## May 2021 BAR Decision

BAR 21-05-01

503 Rugby Road, Tax Parcel 050052000

Project: Modify approved design – entry light fixtures; trim at sections of south and north facades; screening at mechanical units; fence/wall at NW corner.

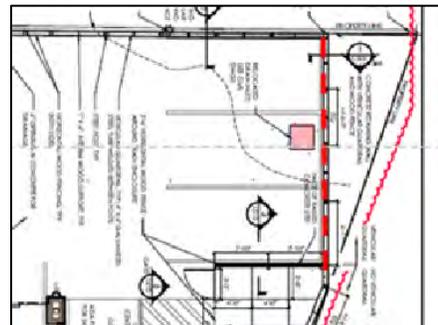
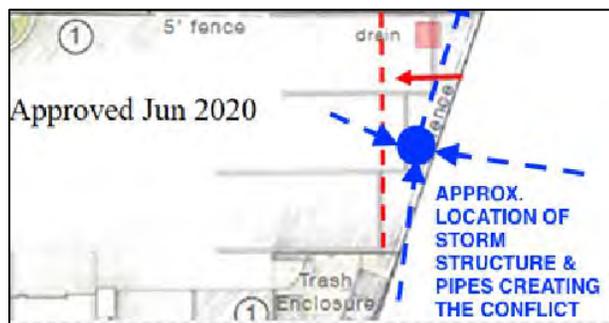
- Staff: No issues. North elevation is at the side, not visible from roads.
- Fence line modified due to existing stormwater structure. (See sheet 6 of submittal.)

- Staff: No issues, this is at the rear, NW corner of parcel. Fence line moved to avoid the structure and provide a vehicular guardrail—a low concrete wall at the fence. The triangular portion will be mulched. (Below: Prior plan, with notes, and the proposed change. Red line is the revised fence location.)

STAIR TOWER REVISED DETAIL

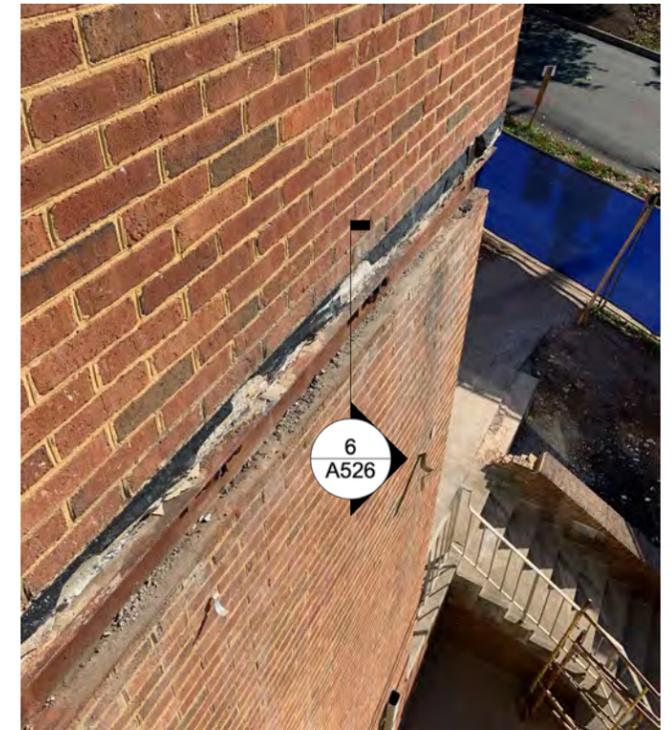
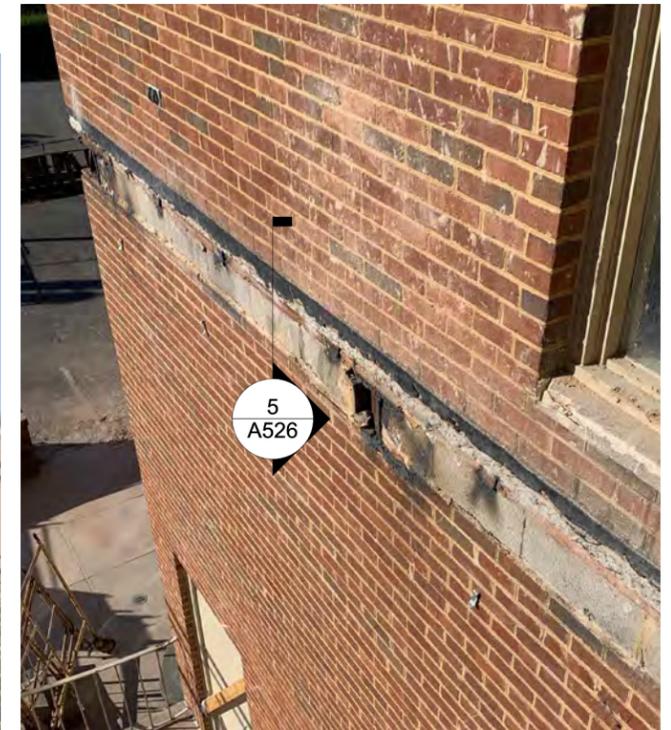
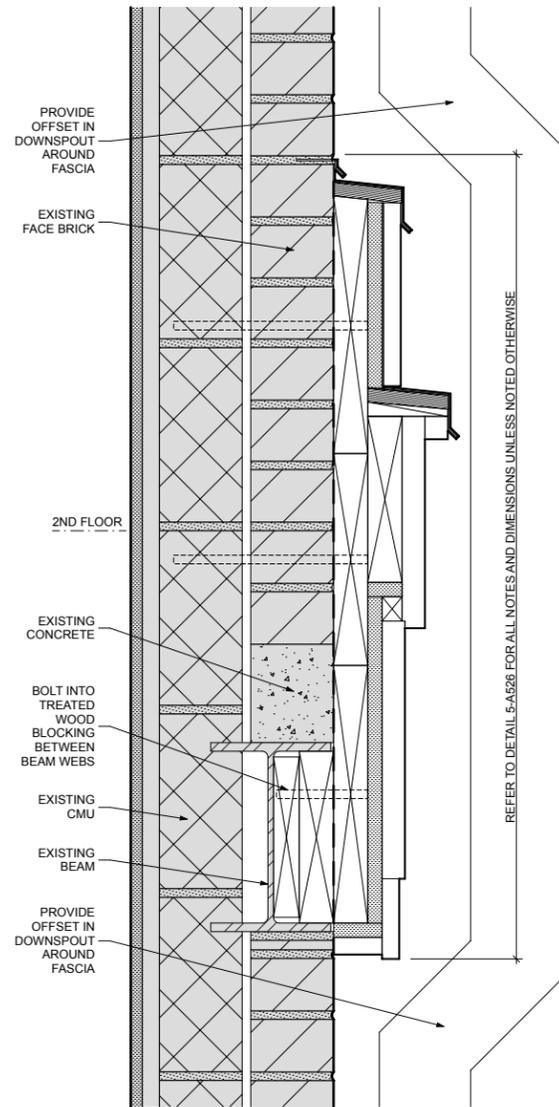
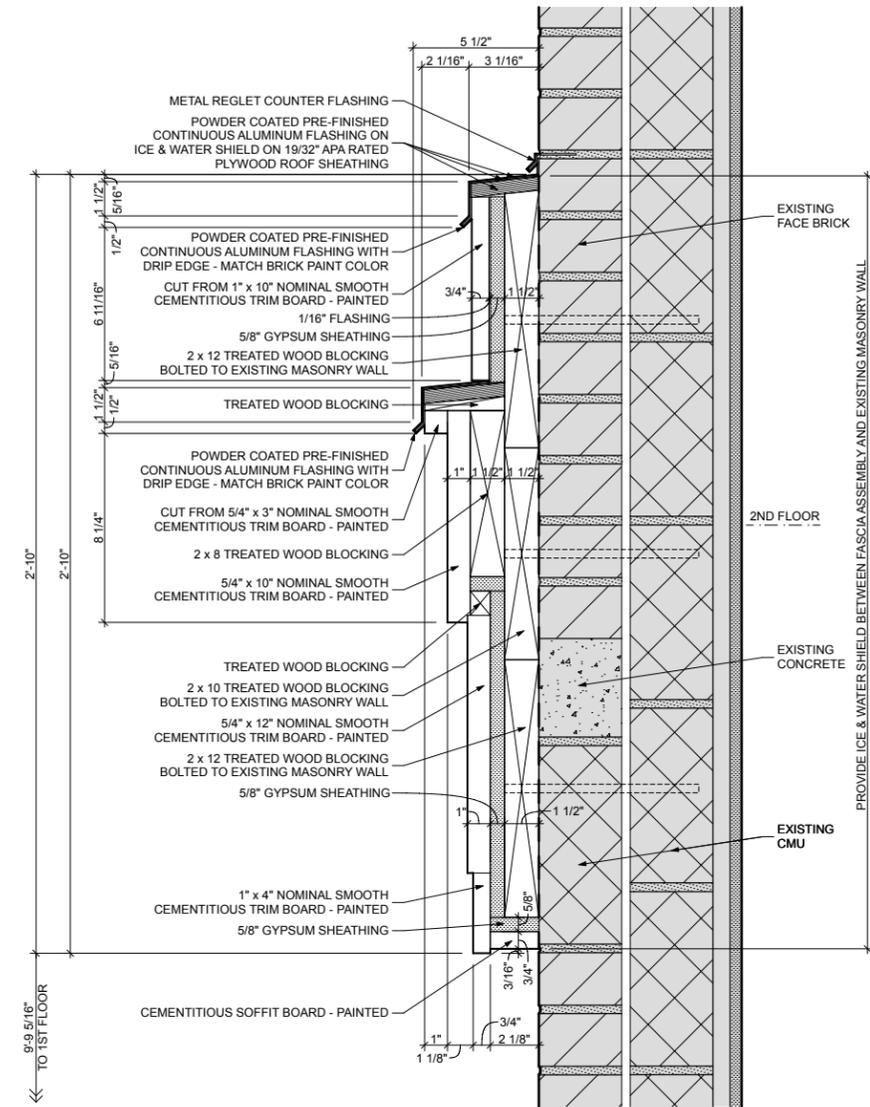
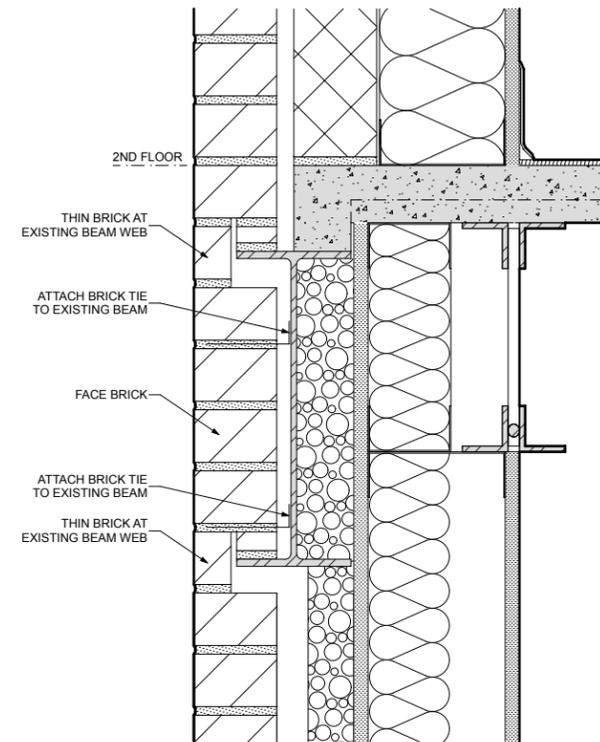
- Alternative entry light fixture. (Approved fixture is unavailable.)
  - Staff: No issues. Proposed is dimmable, CT: 2,700k, CRI: 80
- Install trim at section of south façade to conceal existing concrete slab and metal beam

- Staff: No issues. Necessary to conceal an unforeseen, existing condition. The proposed profile is appropriate and consistent with
- Trim at section of north façade to conceal existing metal beam.

DURING THE COURSE OF DEMOLITION, FOLLOWING REMOVAL OF THE EXISTING BALCONY (SHOWN AT RIGHT) ON THE SOUTH FACADE, THE AS-BUILT CONDITION WAS DISCOVERED TO BE DIFFERENT THAN THE AS-BUILT CONSTRUCTION DOCUMENTS THAT WERE USED FOR THE BASIS OF DESIGN. AS A RESULT, A REVISED DETAIL MUST BE USED TO CONCEAL THE EXPOSED STEEL AND CUT EDGE OF CONCRETE BALCONY SLAB. REFER TO ELEVATIONS ON PREVIOUS PAGE, ABOVE, AND DETAILS ON NEXT PAGE FOR PROPOSED REVISION.

REVISED DETAILING TO MIMIC THE CONDITION AT THE NEARBY SOUTH ENTRY DOOR, REFER TO ENLARGED PARTIAL ELEVATION AND 3D MODEL VIEW BELOW.

REVISED DETAIL AT SIDE ENTRY ON EAST FACADE

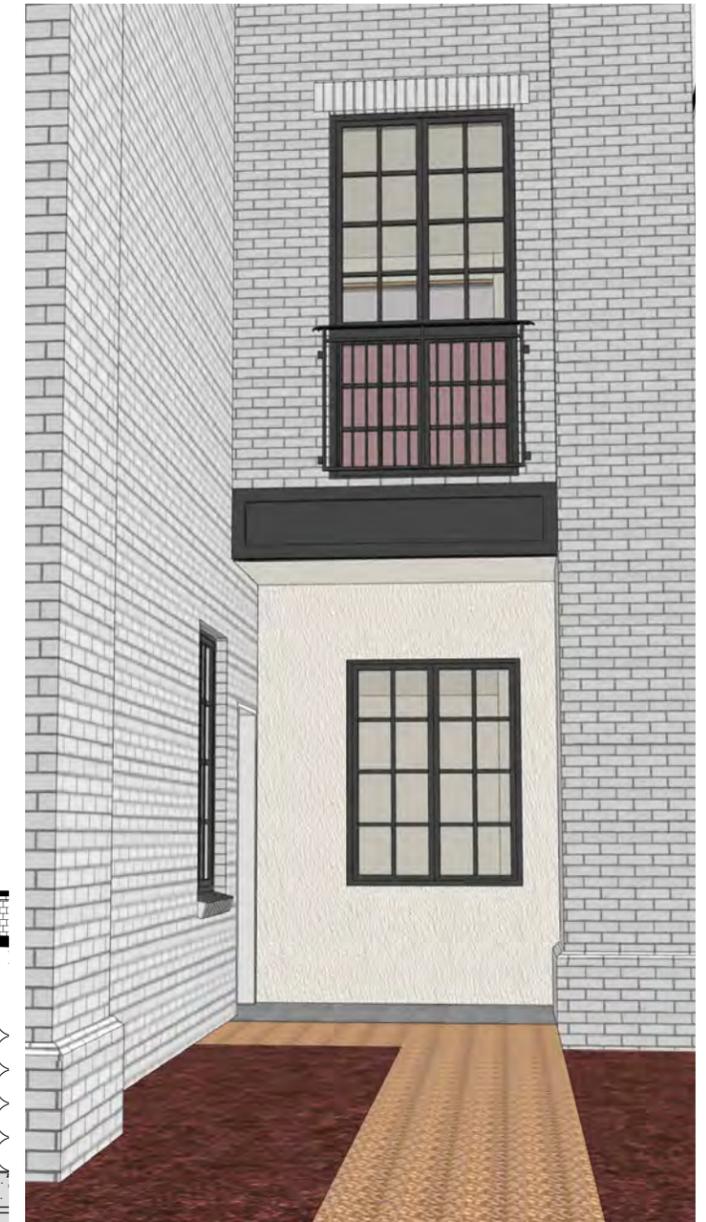
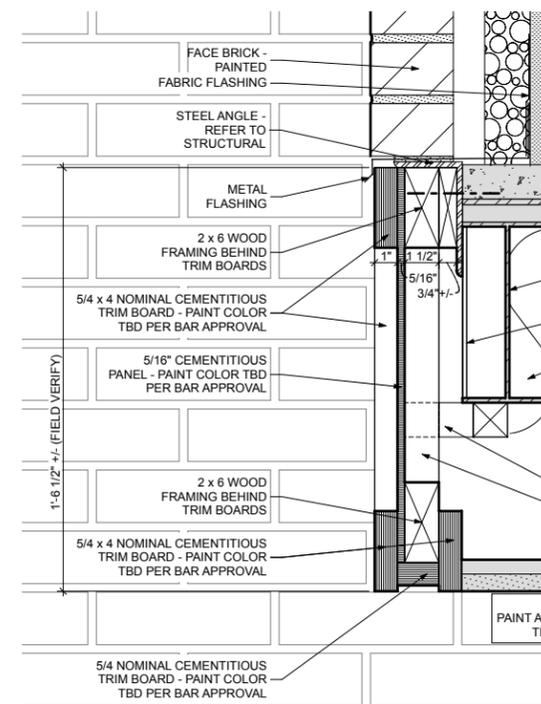
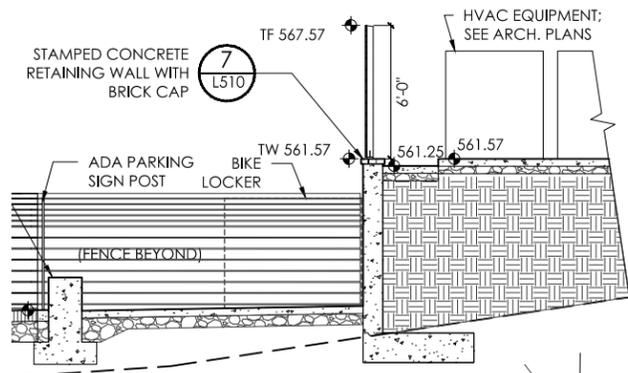
- Staff: No issues. Solution is appropriate and replicates a prior condition.
- Screening at mechanical units at north elevation. (Units taller than planned.)

AN OVERZEALOUS DEMOLITION CREW MISTAKENLY REMOVED THE CAST STONE LINTEL PICTURED ABOVE, THAT WAS ORIGINALLY INTENDED TO REMAIN. (IT WOULD HAVE BEEN A UNIQUE CONDITION.) THE REVISED PROPOSED DETAIL IS A HARDIE BOARD PANEL WITH TRIM SIMILAR TO THAT USED ON THE SOUTH FACADE.

PROPOSED PANEL AND TRIM TO BE PAINTED TO MATCH WINDOWS AND RAILINGS, SIMILAR TO SOUTH FACADE, SEE ABOVE ENLARGED ELEVATION AND 3D MODEL VIEW AND SECTION DETAIL AT LEFT.

REVISED PLANTING PLAN

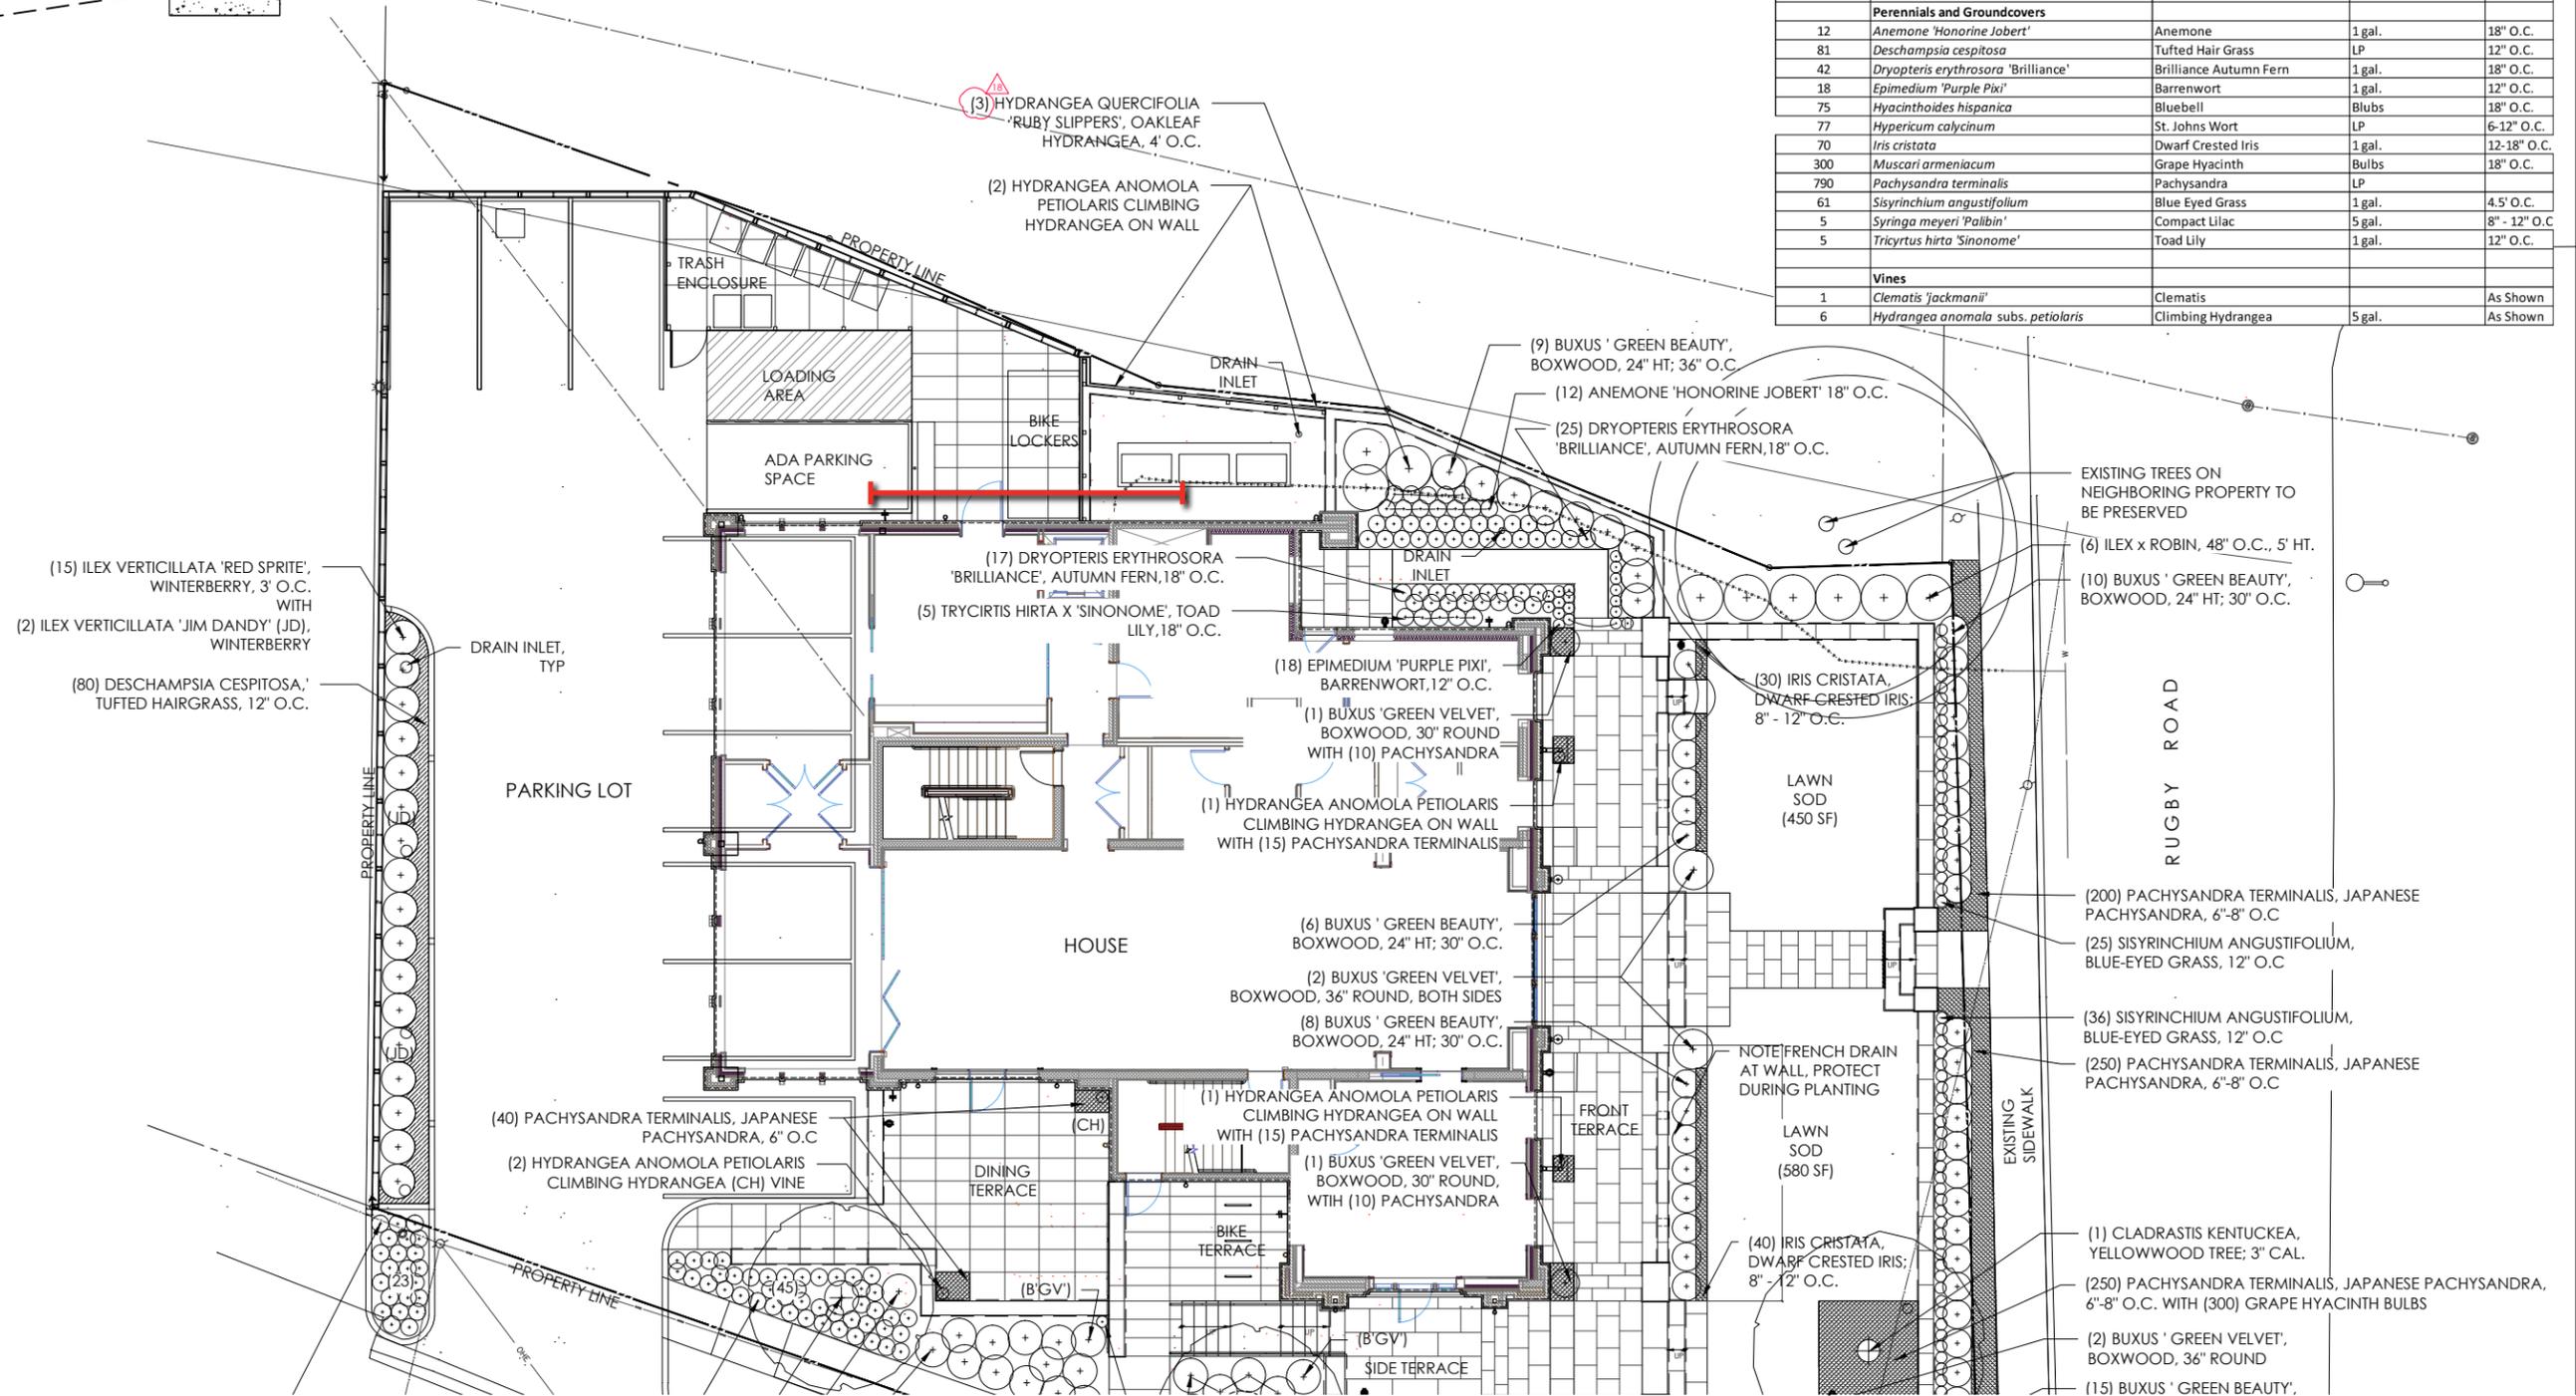
REVISED PLANTING PLAN COORDINATING WITH REVISED CONDITIONS DESCRIBED ON PREVIOUS PAGE. SECTION AT LEFT (WITH LOCATION MARKED ON PLAN) SHOWING FENCE HEIGHT OF 6' SURROUNDING MECHANICAL UNITS.

CUT SHEETS: LIGHTING

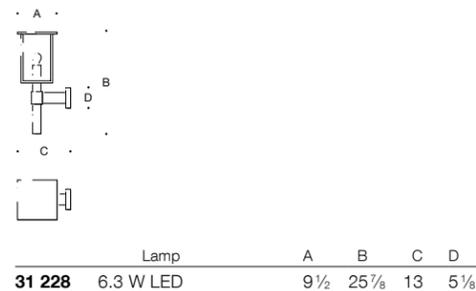
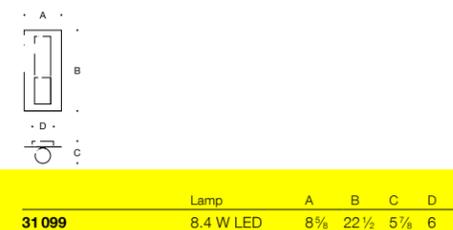
PREVIOUSLY APPROVED,  
 NOW DISCONTINUED FIXTURE  
 LOCATED AT FRONT PORCH  
 ON EAST FACADE.

SELECTED REPLACEMENT  
 FIXTURE
